**Product Change Notification - LIAL-05YDJH355**

CCB 4082.011 Final Notice: Qualification of MTAI as a new final test site for selected LX3301AQPWxx Microsemi device family available in 14L TSSOP (4.4mm) package.

**CCB 4082.011**  
**Pre and Post Change Summary**  
**PCN# LIAL-05YDJH355**

## 14L TSSOP (Package code: D4X)

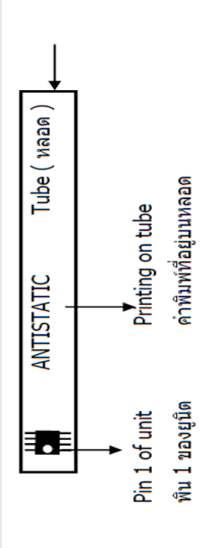
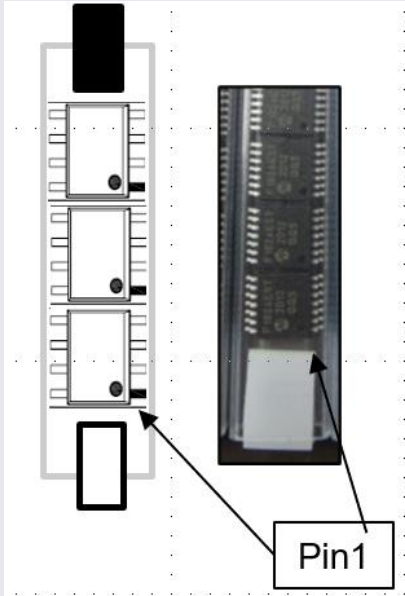
Pre Change					Post Change				
Assembly Site Location	UTAC Thai Limited (UTL-1) LTD. (NSEB)					UTAC Thai Limited (UTL-1) LTD. (NSEB)				
Final Test Location	MSCS San Jose					MTAI				
Packing Media	Tape and Reel					Tape and Reel				
Base Quantity Multiple (BQM)	2500					2500				
Pin 1 Orientation	Quadrant 1					Quadrant 1				
With Desiccant and HIC?	Not Applicable					Not Applicable				
Carrier Tape	Width	Pitch	A0	B0	K0	Width	Pitch	A0	B0	K0
	16mm +/- 0.3	8mm +/- 0.1	6.95mm +/- 0.1	5.60mm +/- 0.1	1.60mm +/- 0.1	16mm +/- 0.3	8mm +/- 0.1	6.80mm +/- 0.1	5.40mm +/- 0.1	1.60mm +/- 0.1
Cover Tape	Width		Thickness			Width			Thickness	
	13.30 +/- 0.1mm		0.053 +/- 0.005mm			13.30 +/- 0.1mm			0.050 +/- 0.010 mm	
Reel	Color	Diameter	Hub Diameter	W1	Color	Diameter	Hub Diameter	W1		
	White	330mm	101.6mm	16.8mm	Dark Blue	330mm	100mm	16.40mm

## 14L TSSOP (Package code: D4X)

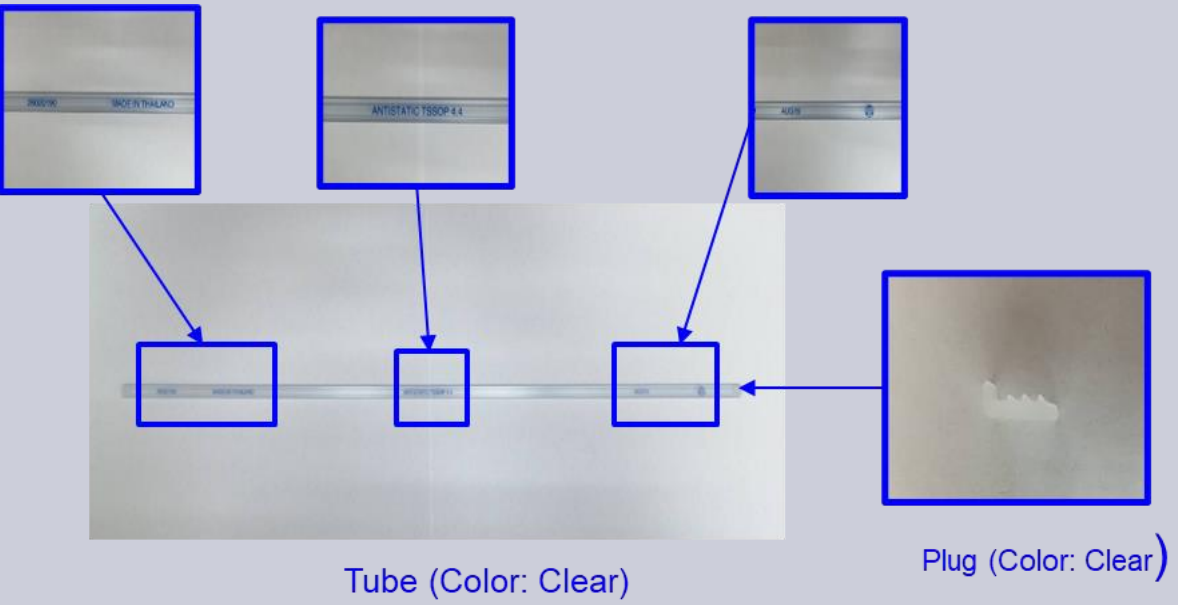
Packing Information	Packing Components / Media	Pre Change (MSCS)	Post Change (MTAI)
Base Quantity Multiple (BQM)	Units/Tube	96	96
Pin 1 Orientation	Tube	<p>Pin 1 of unit must be oriented toward “ANTISTATIC” which is printed located on tube</p>

# Packing Information – Tube

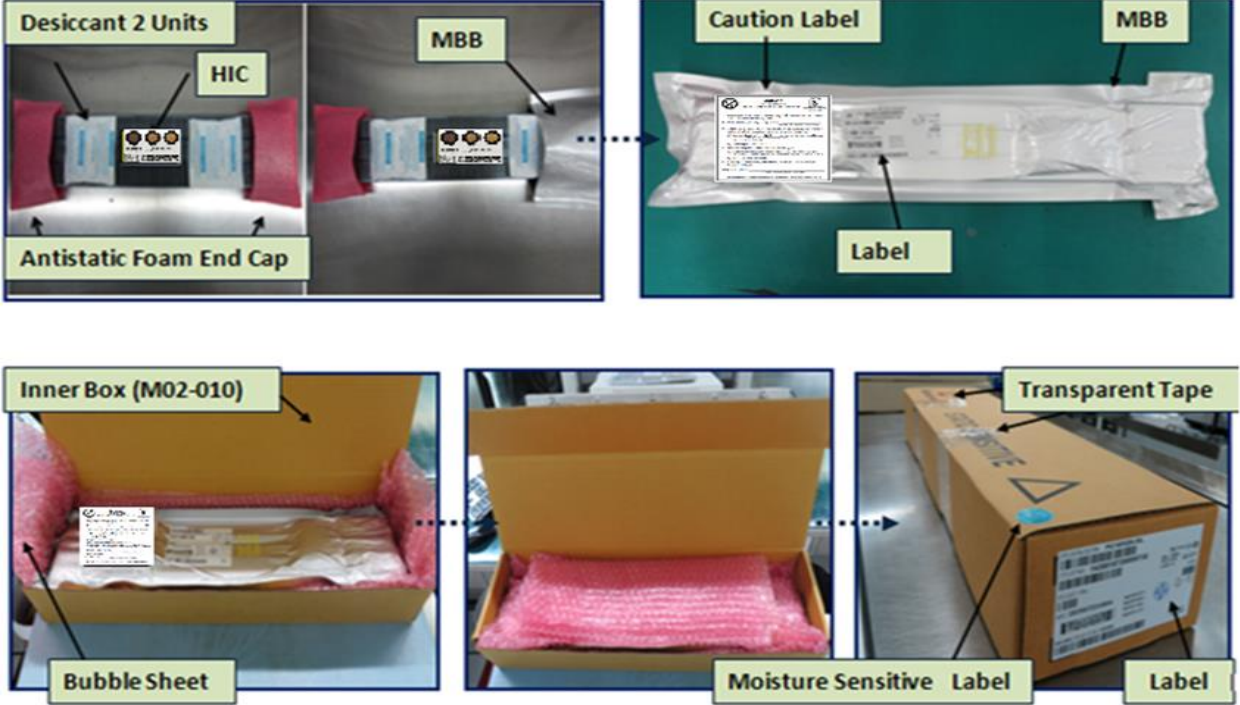
Packing Components	MSCS		MTAI (Non-Dry Pack)		MTAI (Dry Pack)																																
Desiccant	Not applicable		None		2 units per bag																																
Moisture Barrier or Static Sensitive Bag	Width 6.00 (+/- 0.4) inch	Length: 25.236 (+/- 1.0) inch	Width 6.3 inch	Length 25.6 inch	Width 6.3 inch	Length 25.6 inch

Carton Box Dimension	Width: 5.31 inch Length: 21.26 inch Height: 3.35 inch 		<table border="1"> <thead> <tr> <th>Dimension W x L x H (cm)</th> <th>Number of Bag/carton</th> </tr> </thead> <tbody> <tr> <td>15x64x5.5</td> <td>1</td> </tr> <tr> <td>15x64x10</td> <td>2</td> </tr> <tr> <td>15x64x14</td> <td>3</td> </tr> <tr> <td>28x63x11</td> <td>4</td> </tr> <tr> <td>28x63x15.5</td> <td>6</td> </tr> <tr> <td>28x63x20</td> <td>8</td> </tr> </tbody> </table>		Dimension W x L x H (cm)	Number of Bag/carton	15x64x5.5	1	15x64x10	2	15x64x14	3	28x63x11	4	28x63x15.5	6	28x63x20	8	<table border="1"> <thead> <tr> <th>Inner Box</th> <th>Carton</th> <th>Number of Inner box(es) per carton</th> </tr> <tr> <th>Dimension W x L x H (cm)</th> <th>Dimension W x L x H (cm)</th> <th></th> </tr> </thead> <tbody> <tr> <td rowspan="5">12.9x56.5x8</td> <td>15.5x62.0x14.0</td> <td>1 per 1</td> </tr> <tr> <td>28x63.5x11</td> <td>2 per 1</td> </tr> <tr> <td>28x63.5x15.5</td> <td>3 per 1</td> </tr> <tr> <td>28x63.5x20</td> <td>4 per 1</td> </tr> <tr> <td>43x59x19</td> <td>6 per 1</td> </tr> </tbody> </table>		Inner Box	Carton	Number of Inner box(es) per carton	Dimension W x L x H (cm)	Dimension W x L x H (cm)		12.9x56.5x8	15.5x62.0x14.0	1 per 1	28x63.5x11	2 per 1	28x63.5x15.5	3 per 1	28x63.5x20	4 per 1	43x59x19	6 per 1
